**Shady Grove Adventist Hospital Aquilino Cancer Center, Site Plan Amendment & Final Water Quality Plan 81999024H**

Completed: 10/28/11

Site Plan (Detail)

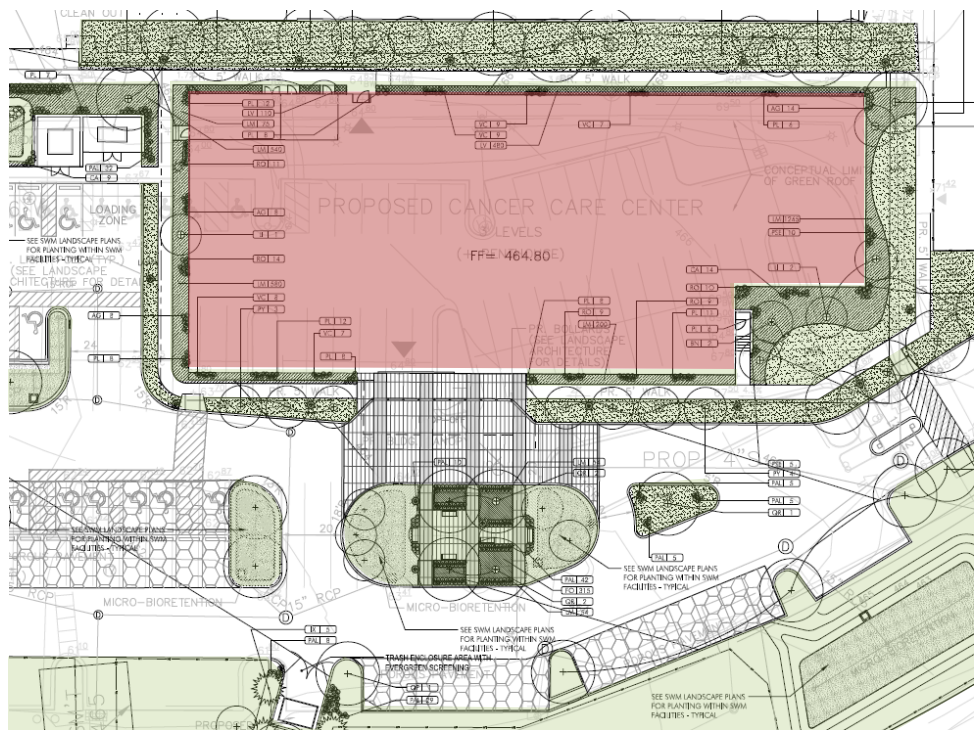
The proposed Cancer Center will replace 111 existing surface parking spaces and use sidewalks and landscaping to functionally tie the Center to the hospital grounds. New stormwater facilities, an entry drop-off/seating area, and ancillary site features are also being added. The reduction in parking spaces will result in 1,961 remaining spaces, well above the 1,720 spaces required for the uses on site.
